SUBDIVISION REPORT - CONCEPT/DEVELOPMENT PLAN

▶ **FILE #:** 3-SB-26-C
3-F-26-DP

▶ **SUBDIVISION:** EMORY GREEN TOWNHOMES

▶ **APPLICANT/DEVELOPER:** BALL HOMES, LLC

C1.01
CONCEPT PLAN
01/15/25

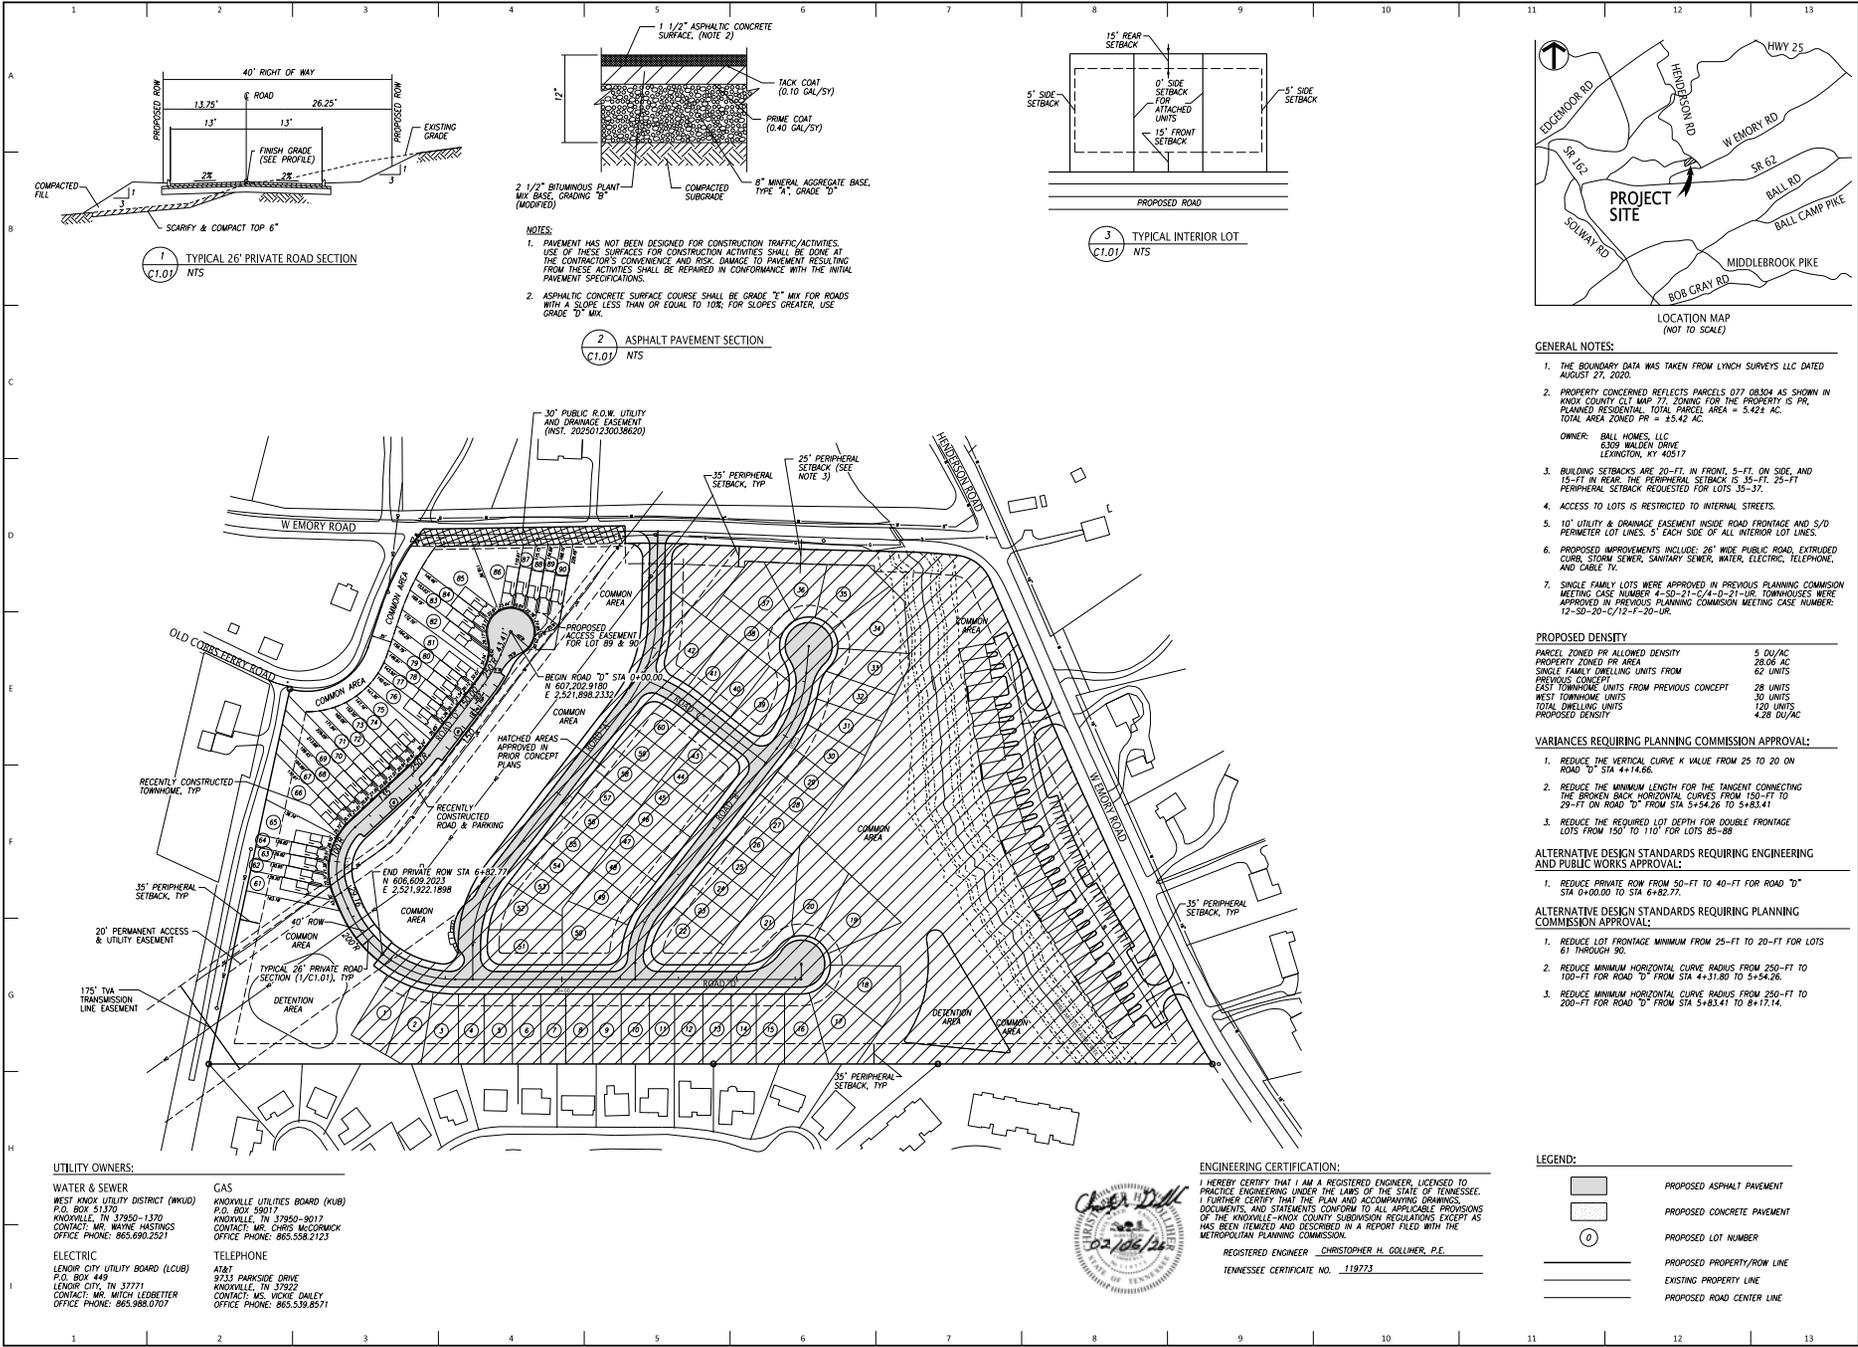
▶ **SUBDIVISION VARIANCES REQUIRED:** **VARIANCES:**
1. Reduce the K value from 25 to 20 on Road D STA 4+14.66.
2. Reduce the minimum length for the tangent connecting broken back horizontal curves from 150 ft to 29 ft on Road D from STA 5+54.26 to 5+83.41.
3. Reduce the lot depth for double frontage lots 85-88 from 150 ft to 110 ft.

1. Reduce the minimum lot frontage from 25 ft to 20 ft for lots 61-90.
2. Reduce the minimum horizontal curve radius from 250 ft to 100 ft for Road D from STA 4+31.80 to 5+54.26.
3. Reduce the minimum horizontal curve radius from 250 ft to 200 ft for Road D from STA 5+83.41 to 8+17.14.

1. Reduce the private right-of-way width from 50 ft to 40 ft for Road D from station 0+00.00 to station 6+82.77.

- Approve the variance to reduce the K value from 25 to 20 on Road D STA 4+14.66.
- A. Due to the existing steeper topography along Road D, a reduction of the vertical curve length is needed to keep site grading balanced.
 - B. The topography and shape of the property are unique and have not been created by any person having an interest in the property.
 - C. This is a road with low traffic volumes, and the variation is not great enough to cause detriment to public safety, health, or welfare, nor would it be injurious to other properties in the neighborhood. Knox County EPW recommends approval of this variance based on the justifications provided by the applicant.

Approve the variance to reduce the minimum length for the tangent connecting broken back horizontal curves from 150 ft to 29 ft on Road D from STA 5+54.26 to 5+83.41.

- A. Due to the existing steeper topography along Road D and the TVA transmission tower, a reduction in tangent length is needed to construct the road.
- B. The existing topography, shape of property, and TVA tower are unique and have not been created by any person having an interest in the property.
- C. This is a road with low traffic volumes, and the variation is not great enough to cause detriment to public safety, health, or welfare, nor would it be injurious to other properties in the neighborhood. Knox County EPW recommends approval of this variance based on the justifications provided by the applicant.

Approve the variance to reduce the lot depth for double frontage lots 85-88 from 150 ft to 110 ft.

- A. A 30-ft right-of-way easement is required by County Engineering in the rear of lots 85-88. This easement cannot be within common area. Without a common area buffer, a variance is required for the reduction in lot depth.
- B. The right-of-way easement at this location is unique to this property.
- C. The right-of-way easement is necessary for public safety, health, or welfare. Knox County EPW recommends approval of this variance based on the justifications provided by the applicant.

Approve the alternative design standards based on the justification provided by the applicant and recommendations of the Knox County Department of Engineering and Public Works.

Approve the Concept Plan subject to 8 conditions.

ROAD D
SCALE: 1"=50' HORIZ
1"=10' VERT

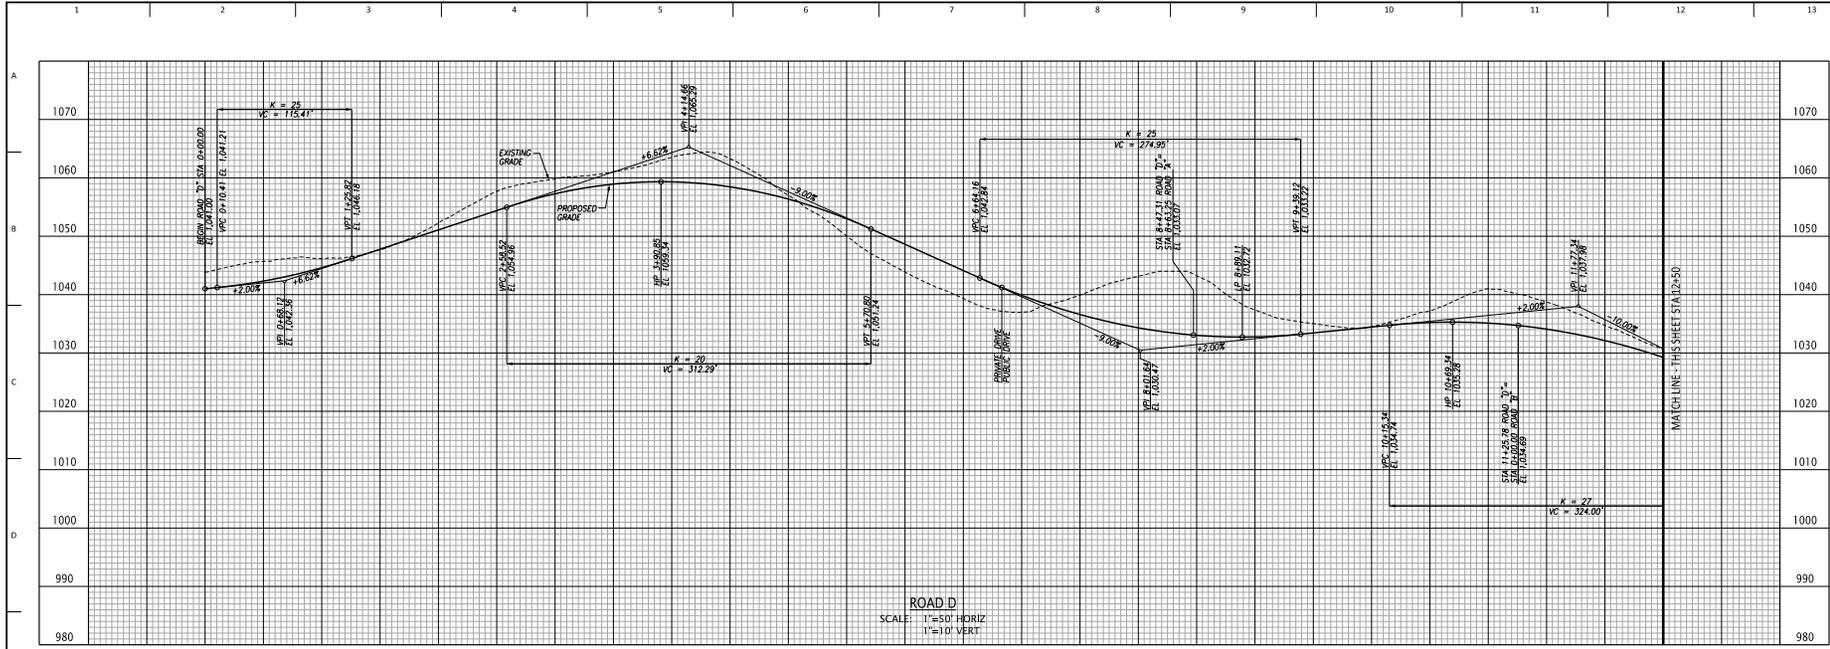
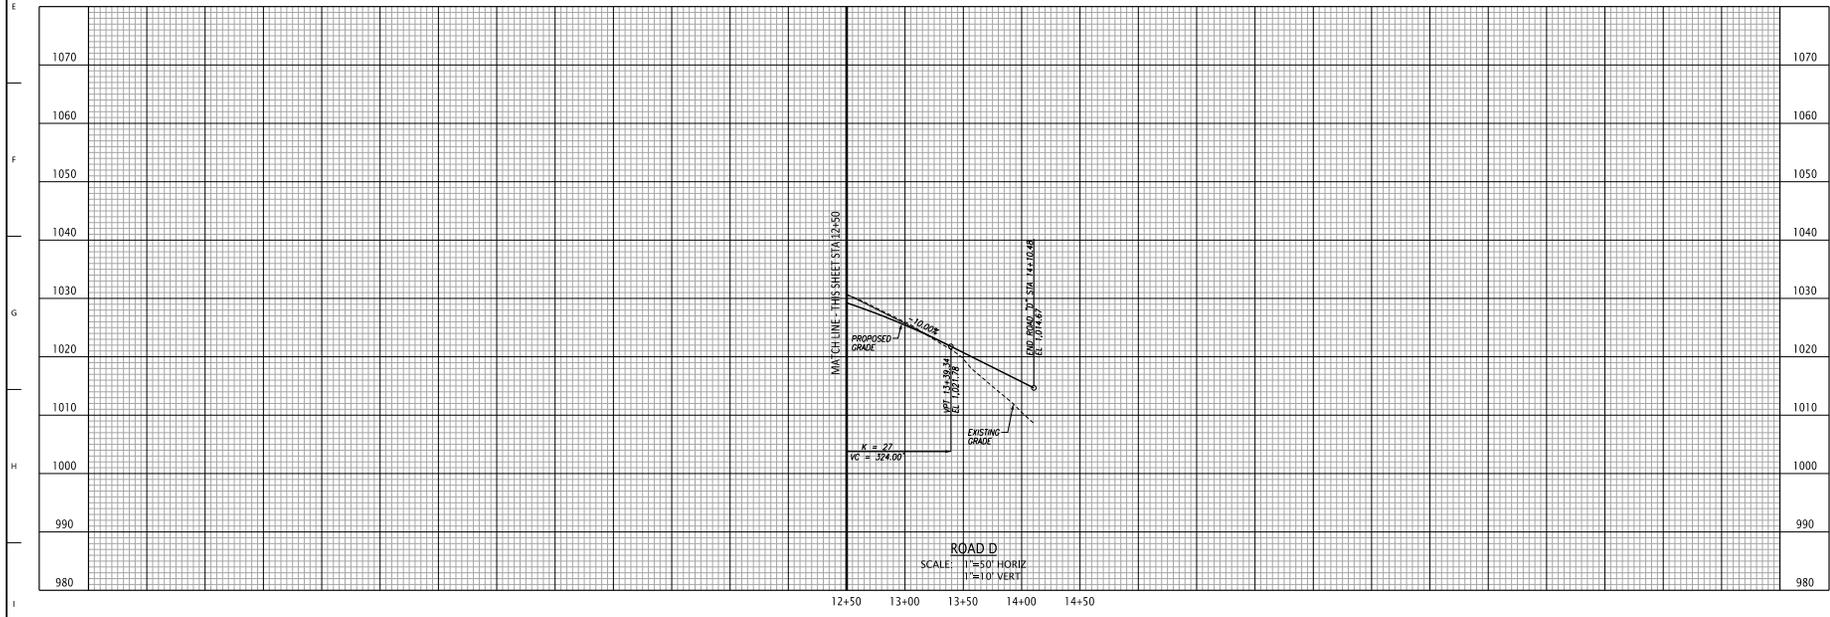
Reduce the vertical curve K value from 25 to 20 on Road "D" STA 4+14.66.

Reduce the minimum length for the tangent connecting the broken back horizontal curves from 150' to 29' on Road "D" from STA 5+54.26 to 5+83.41
